IN THE DRAWINGS:

REMARKS

This amendment is submitted in response to the Notice of Non-compliant Amendment issued January 5, 2006 to correct the status designation of amended Claim 3 as being "Currently Amended". Otherwise, the contents of this amendment is identical to applicant's previously submitted amendment of December 20, 2005.

FIG. 2
Prior Art

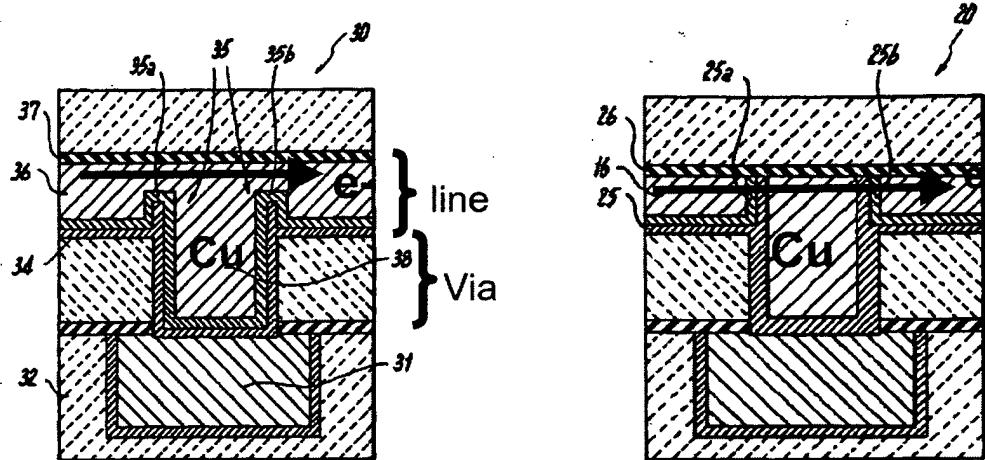
Further in the Office Action, the Examiner rejected Claims 1-6 under 35 U.S.C. §102(b) as allegedly being anticipated by Wang et al. (U.S. Patent No. 6,383,920) (“Wang”).

Applicants respectfully disagree. As shown illustrated below, Figure 2 of the present drawings depict the embodiment described in Wang (e.g., corresponding to Figures 2H and 2L of Wang), which clearly shows, after a second chemical mechanical polish step, the resulting structure where the liner material 25, 25a and 25b completely blocks the electro path in the line level. In the present invention shown below, and as set forth in Claims 1 and 5, only a portion of the metal liner extends partially into an adjacent metal level of the first and second metal levels. Clearly, Wang does not teach or suggest such a feature. Wang show a process for fully encapsulating a copper via in a semiconductor device as a way to prevent void formation in the bottom of the via due to electromigration.

However, the present invention enhances the electromigration resistance, i.e., slows down electromigration phenomena (see paragraph [0034] of the present specification) by extending a portion of the metal liner partially into an adjacent metal level of the first and second metal levels which structure is neither taught by nor suggested in Wang. This partial extension of the liner according to the invention forces electrons to go “around the fence” and flow down through the via that eliminating the current crowding effect and thus, less migration.

extends into an adjacent metal level of the first and second metal levels (no complete extension) and again this is neither taught nor suggested in Wang.

As such, the Examiner is respectfully requested to withdraw the rejection of Claims 1-6 as being anticipated by Wang.
